SPARE PARTS LIST

CHAIN SAWS

555

Illustrated Parts List - IPL Update

A 555
CHAIN BREAK & CLUTCH COVER

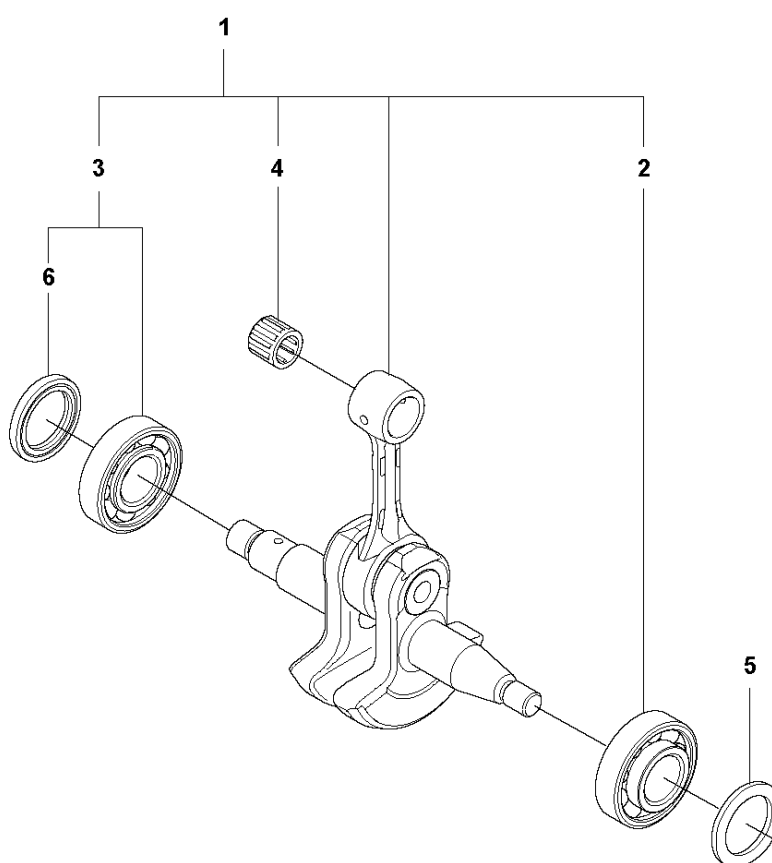
1. Handguard: Reinforced.
2. Clutch cover assy: Updated version of internal parts, the brake band assy and the chain tensioner parts.
3. Brake band assy: Updated version, with out slots.

4. A new kit with chain tensioner parts (Worm screw, Pawl, Worm wheel) with right hand thread. The left hand thread parts are replaced but remain as a spare part for other products.

Page Title	Ref. no	New part no	Name	Excluded part no.	Remark
Chainbrake and clutch cover	1	5052009-02	Handguard	5052009-01	
	5	5051990-06	Clutch cover assy	5051990-02	
	10	5051995-02	Brake band assy	5051995-01	
	15	5752604-03	Chain tensioner kit	5752604-01	
	18	5372865-01	Worm screw		Remain as a spare part for other products.
	19	5372866-01	Pawl		Remain as a spare part for other products.
	21	5370794-02	Worm wheel		Remain as a spare part for other products.
Carburator and airfilter	1	5051263-04	Air filter assy (80my)	5051263-01	
	1	5051263-05	Air filter assy (44my)	5051263-02	
	1	5051263-06	Air filter assy (Felt)	5051263-03	
Fuel Tank	15	5846470-01	Antivibration element	5782274-01	Remain as a spare part for other products.
	19	5226200-01	Tank cap assy	5441112-01	Remain as a spare part for other products.
Crankcase	5	5753802-07	Crankcase assy	5753802-02	
	17	5032008-03	Screw		6pcs (was 5pcs).
	26	5226200-01	Tank cap assy	5441112-01	Remain as a spare part for other products.

B 555
CLUTCH & OIL PUMP

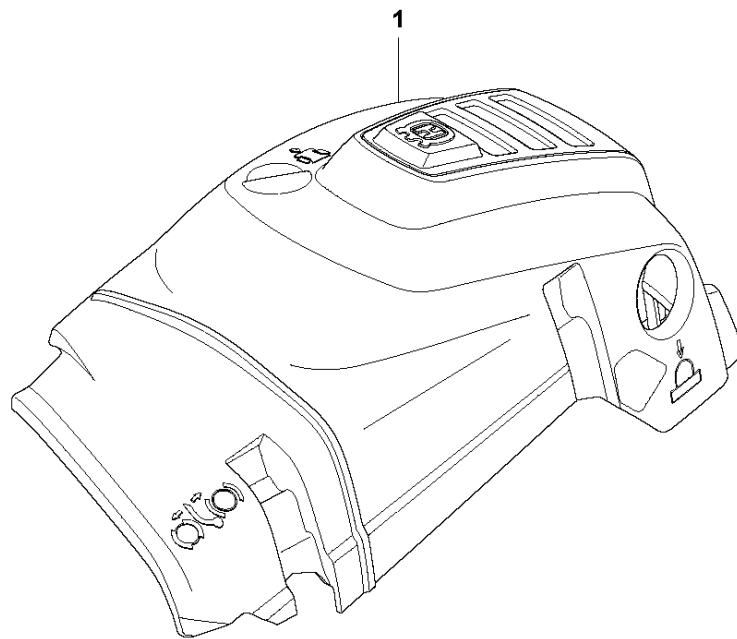
9. Clutch assy: New improved clutch shoe and new improved spring.
10. Crankshaft: New spare part assy due to new internal part, Needle bearing. See note no.11.

5806535-02, clutch spring. The old clutch spring will be replaced by the new clutch assy.

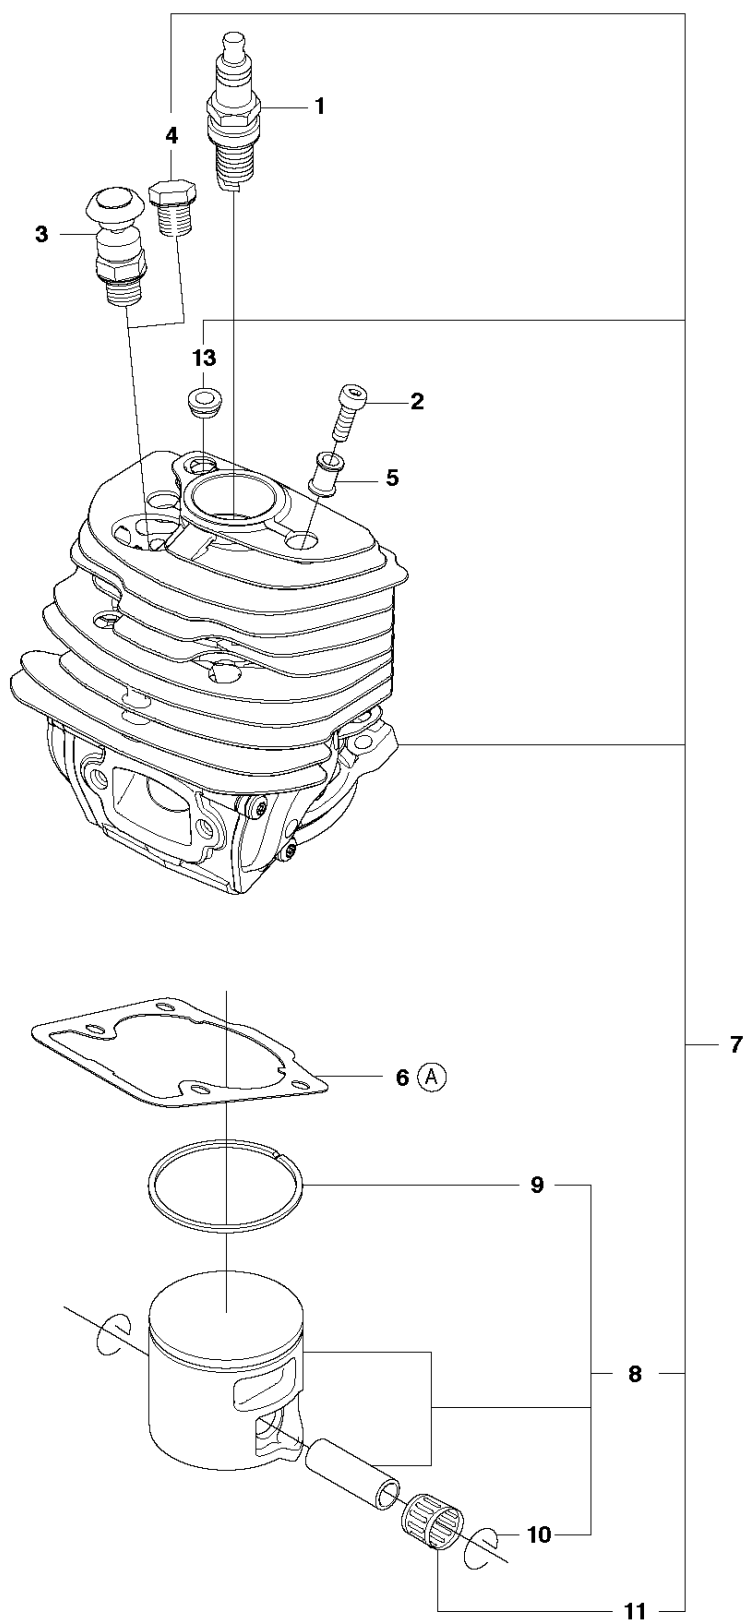
5. Air filter assy: Sealing and snap function between filter halves have been modified to ensure better sealing.
6. Tank cap assy: New type of tank cap with a flip up grip and folded back when not in use. Used for both fuel and oil tank.

7. Crankcase assy: Reinforced Crankcase. An extra screw with a new gasket and an improved sealing funktion.
8. Muffler: New improved muffler, higher durability.
